**CITY OF CODY**  
**PLANNING, ZONING AND ADJUSTMENT BOARD AGENDA**  
**TUESDAY, AUGUST 22, 2023 AT 12:00 P.M. (NOON)**  
**CODY CITY HALL, COUNCIL CHAMBERS, 1338 RUMSEY AVENUE, CODY, WY**

**CITY OF CODY  
PLANNING, ZONING AND ADJUSTMENT BOARD  
STAFF REPORT**

<b>MEETING DATE:</b>	AUGUST 22, 2023	<b>TYPE OF ACTION NEEDED</b>	
<b>AGENDA ITEM:</b>		P&Z BOARD APPROVAL:	
<b>SUBJECT:</b>	FINAL PLAT AND CONSTRUCTION PLANS FOR THE KHAN UNIT DEVELOPMENT SUBDIVISION—A 3-LOT COMMERCIAL SUBDIVISION. SUB 2023-02	RECOMMENDATION TO COUNCIL:	X
<b>PREPARED BY:</b>	TODD STOWELL, CITY PLANNER	DISCUSSION ONLY:

# KHAN UNIT DEVELOPMENT SUBDIVISION

The wall packs are proposed to be located as shown below (yellow highlight).

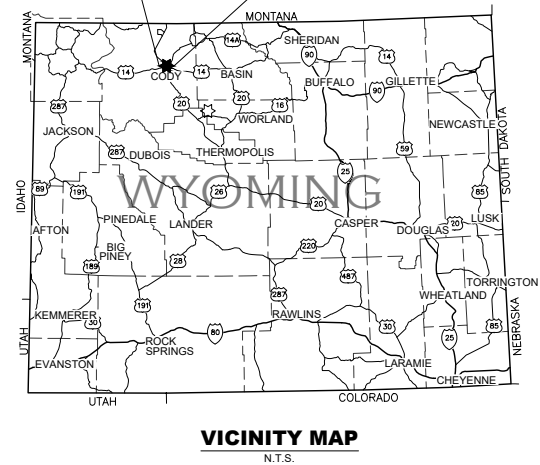
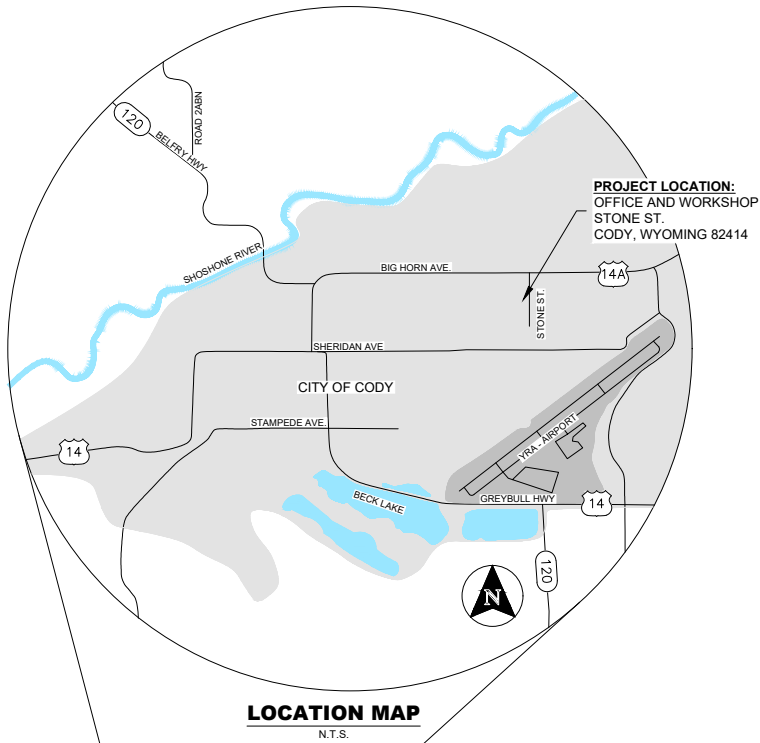
1. Coordinate the transformer location with the electric division. Provide additional easement if necessary for the transformer location.
2. Mount the wall packs to point directly down.
